Access Compliance Report Public Rights-of-Way (Curb Ramps)

Main Street: **STANTON_AVE** Cross Street: **ASHGROVE_DR** Location: **NE**

ADA ID: **RPAT210921102931** Ramp Type: **Type 1 - Perpendicular Diagonal** Initial Pass/Fail: **Pass** Overall Compliance: **No** Severity Score: **22**

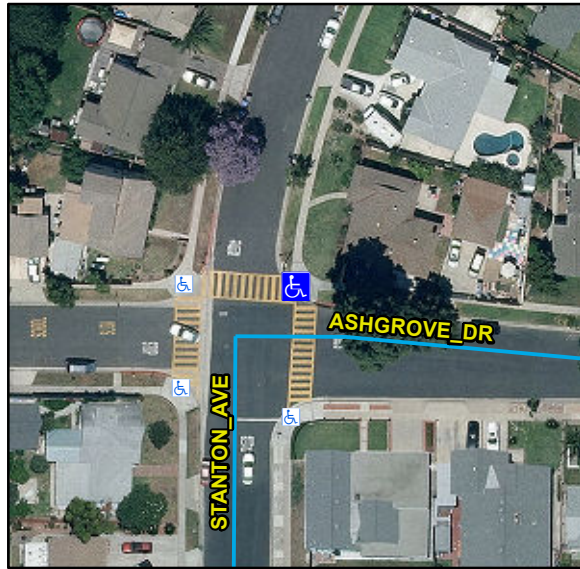
R304.2.1, R304.5.3, R304.2.3, R302.7.2, STD 1115

Remove & Replace Curb Ramp With Two New Directional Ramps or Equivalent. Grind Gutter Lip.
